RE: El Dorado Chemical Company Inspections (Union Co)

AFIN: 70-00040 NPDES Permit No.: AR0000752

AFIN: 70-00040 - NPDES Permit No. AR0000752 Response to Compliance Evaluation Inspection

Figure 1. Overview of El Dorado Chemical Company with location of treatment lakes and outfalls identified.

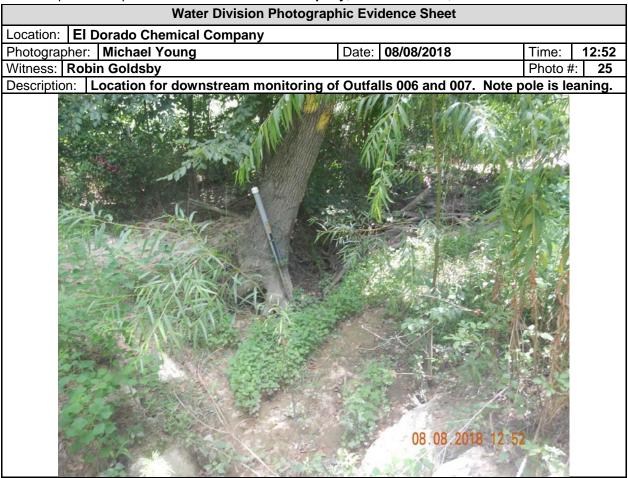
3. "The facility is monitoring downstream flow for Outfall 006 and 007 with a flow monitoring device that has not been maintained properly (see Photos 24-25). Additionally, calibration records were not available during the inspection. This is a violation of permit conditional Part II. (15.)."

The in-stream flow monitoring device shown in Photos 24-25 and as indicated in Figures 1 and 2 of the inspection report is not the device nor the location used to satisfy the in-stream monitoring requirements for Outfalls 006 and 007. During the initial setup phase, the entire drainage tributary between Outfalls 006 and 007 and EDCC's property line was investigated for potential in-stream monitoring location sites. Monitoring equipment was initially installed at multiple locations to aid in the identification of a suitable site with regards to stream channel geometry and dynamics (lag time, infiltration, time of travel, etc.) of the drainage system. The site evaluated and detailed in the inspection report was the downstream most location used during the identification of the suitable site and was not the location chosen as EDCC's in-stream monitoring site.

Figure 2. Topographic view of EDCC. Identified are Outfalls 006 and 007, the downstream flow monitoring, and areas of drainage to the downstream monitoring location that are not associated with Outfalls 006 and 007 (circled in red).

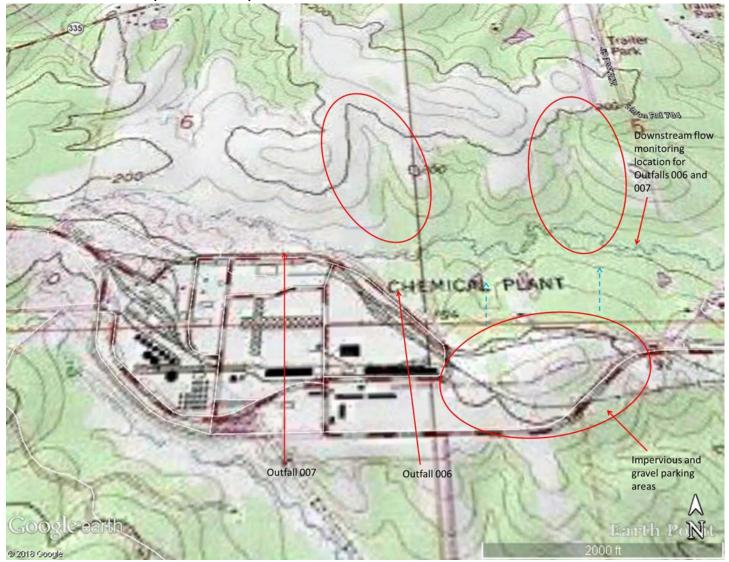
- 4.) The location of the downstream flow device is not representative of discharges from Outfalls 006 and 007 (see Figure 2). This is a violation of permit condition Part III. (C.) (2).

4. "The location of the downstream flow device is not representative of discharges from Outfalls 006 and 007 (see Figure 2). This is a violation of permit condition Part III. (C.) (2)."

The in-stream flow monitoring device shown in Photos 24-25 and as indicated in Figures 1 and 2 of the inspection report is not the device used to satisfy the in-stream monitoring requirements for Outfalls 006 and 007. As indicated above, during the initial setup phase, multiple locations were evaluated for the in-stream monitoring location. Monitoring equipment was installed (and is still in-place) at this location, however, this site was not chosen and is no longer being used.

The area maps provided in Attachment 2 shows the current location of the downstream monitoring device. This location is representative of discharges from Outfalls 006 and 007, as well as the upstream watershed flow that is required to be calculated (Upstream Flow = Downstream Flow – Outfall 006 Flow - Outfall 007 Flow) and reported as part of Condition 13 of Part II and detailed in Section 13.A.1.ii (Fact Sheet) of EDCC's current permit.
